Access Compliance Report

Public Rights-of-Way

(Curb Ramps)

Intersection ID: N/A	Main Street: HORACE_ST	Cross Street: N/A	Location: SE
ADA ID: EEA370C3CD6F	Ramp Type: Perp	Initial Pass/Fail: Fail	Overall Compliance: No
		Severity Score: 12.5

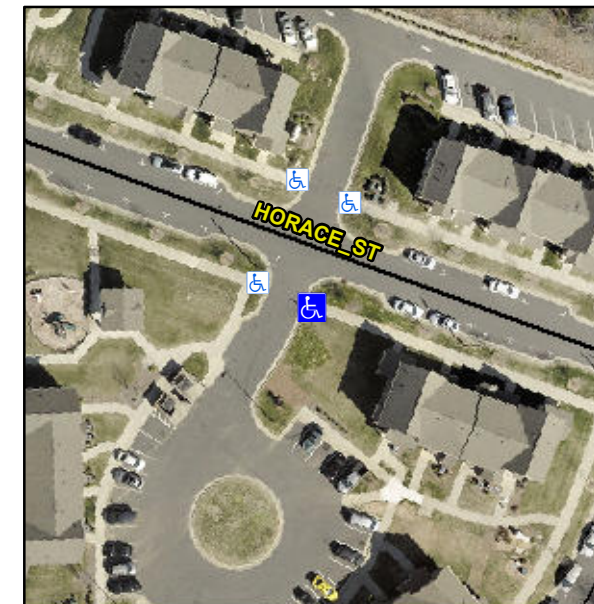
R304.2.2

Compliance	Description	Data	Compliance	Description	Data
N/A	Ramp Length (in)	72.5	No	Ramp Slope (%)	9.1
Yes	Ramp Width (in)	71.0	Yes	Ramp XSlope (%)	0.9
N/A	Flare Type LT	N/A	N/A	Flare Type RT	N/A
N/A	Flare Slope LT (%)	N/A	N/A	Flare Slope RT (%)	N/A
N/A	Flare Traversable LT?	N/A	N/A	Flare Traversable RT?	N/A
N/A	Landing Length (in)	N/A	N/A	DWS Provided?	N/A
N/A	Landing Width (in)	N/A	N/A	DWS Contrast?	N/A
N/A	Landing Slope (%)	N/A	N/A	DWS Length (in)	N/A
N/A	Landing X Slope (%)	N/A	N/A	DWS Full Width?	N/A
N/A	Landing Curb? (Y/N)	N/A	N/A	DWS Offset (in)	N/A
N/A	Shared Landing?	N/A			
N/A	Gutter Ponding?	N/A	N/A	Gutter Slope (%)	N/A
N/A	Gutter Lip Ht (in)	N/A	N/A	Gutter X Slope (%)	N/A
N/A	Painted X Walk1?	No	N/A	Painted X Walk2?	N/A
	X Walk 1 Direction	To NW		X Walk 2 Direction	N/A
N/A	X Walk 1 Width (in)	N/A	N/A	X Walk 2 Width (in)	N/A
	X Walk 1 Slope (%)	4.0		X Walk 2 Slope (%)	N/A
	X Walk 1 X Slope (%)	1.8		X Walk 2 X Slope (%)	N/A

Remove & Replace Entire Ramp.
